***TECHNICAL SPECIFICATIONS
PUBLICATIONS LIST
RECALL CAMPAIGN
SERVICE BULLETIN INDEX***

**328 / 328
GTB / GTS**

Ferrari Servizio Assistenza Tecnica

FERRARI NORTH AMERICA

PREVIOUS TYPE

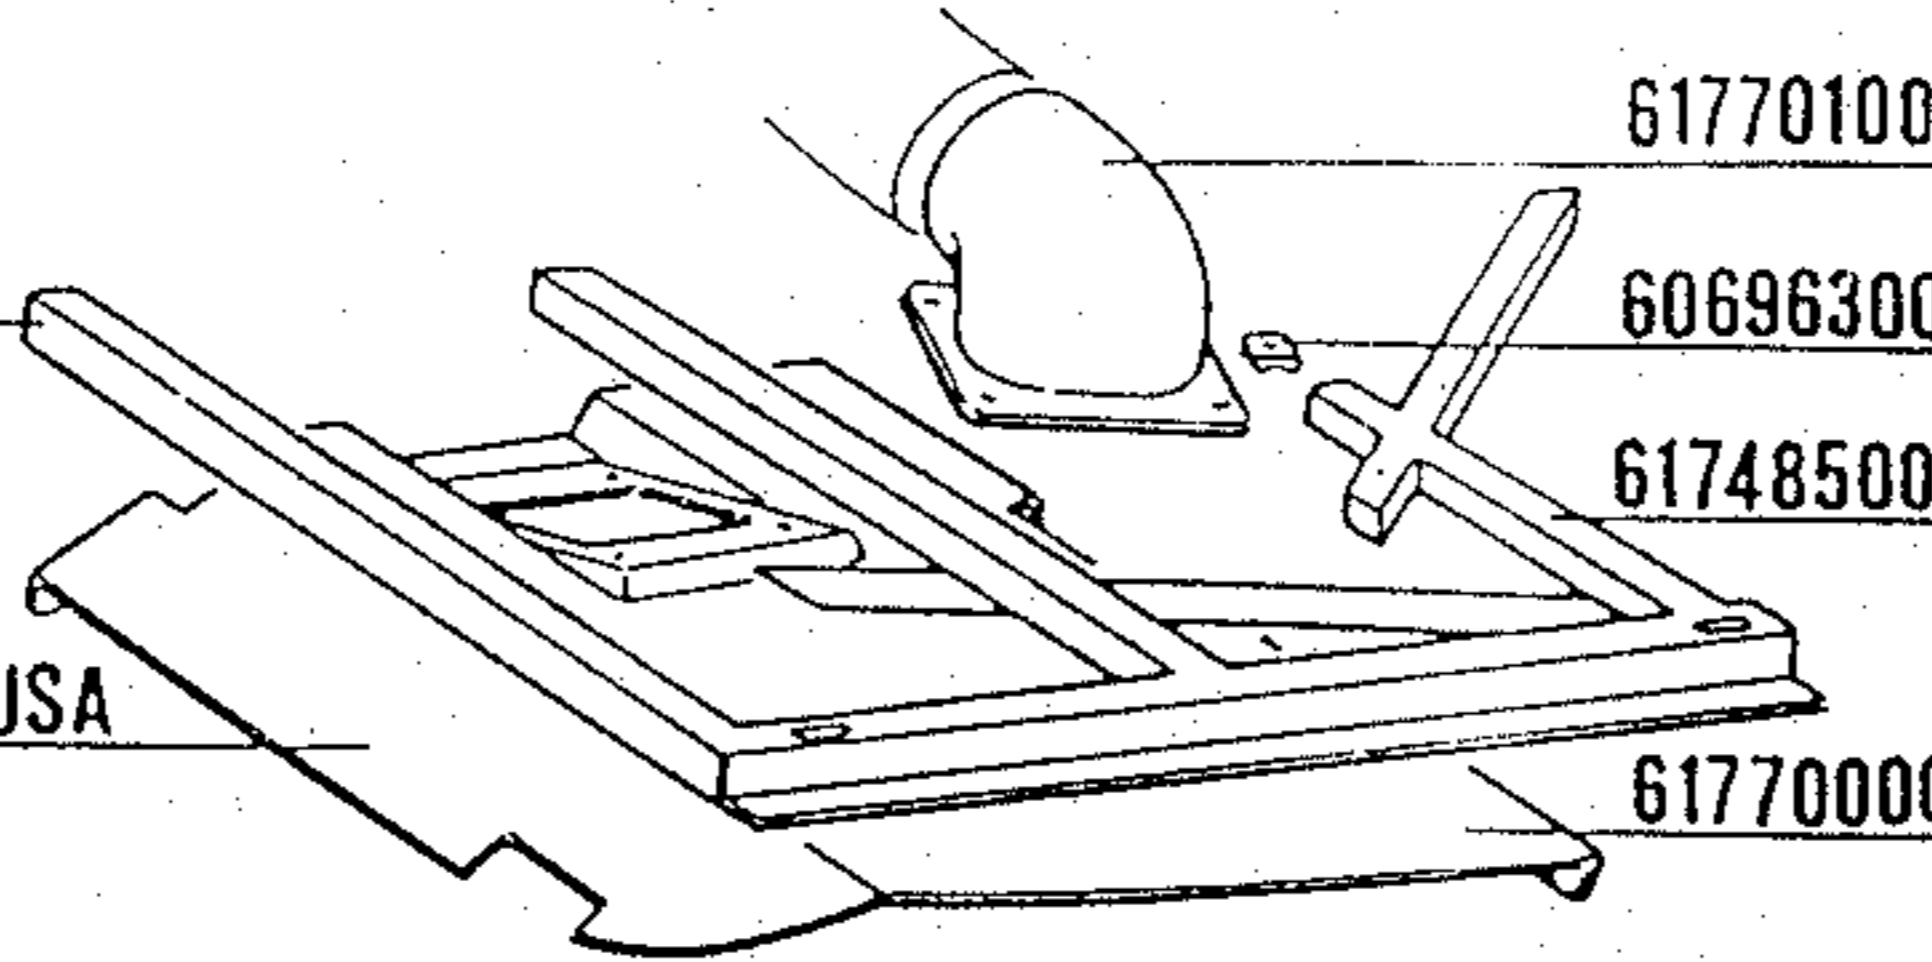
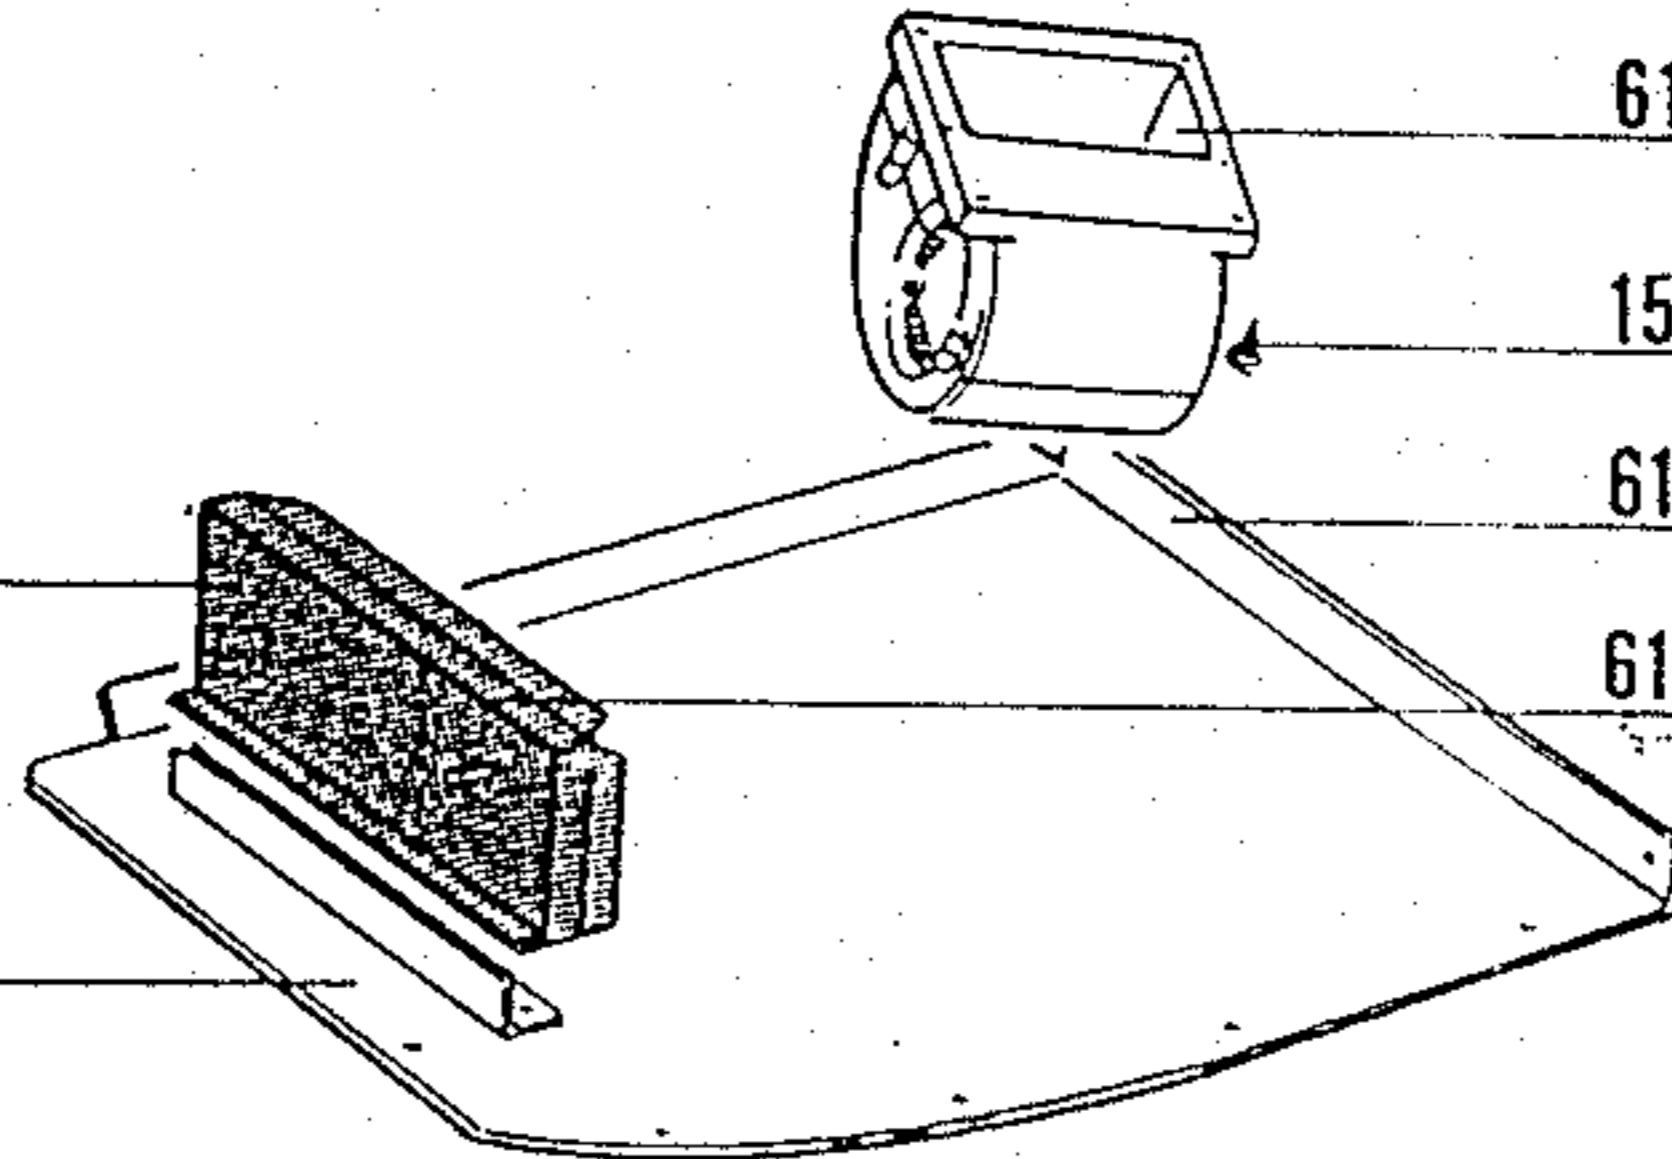
Spare parts procedures: The new heater fan motors are not interchangeable with the previous type. The part numbers for the new parts can be found on the attached drawing.
